SUBMISSION BY DAVINA PENNY. (ADDRESSING OF REBUTTAL BY APPLICANT)

IN THE CASE OF:- APPLICATION BY FULTON HOGAN TO OPERATE A QUARRY, DAWSONS ROAD, TEMPLETON.

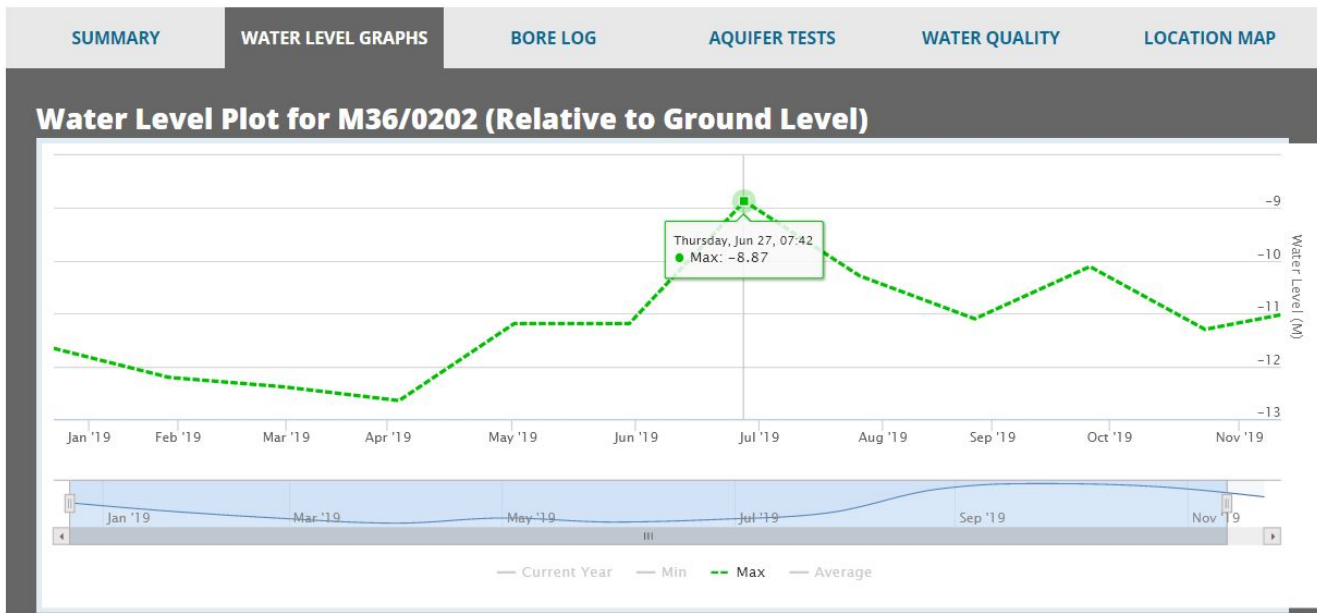
This image is taken from the initial Golder report forming part of the application. As you can see, the blue line representing this well does not indicate that level - at all. The red dot is what I have included to represent where the graph **should** have shown the HRGWL.

This is misleading and misrepresentative.
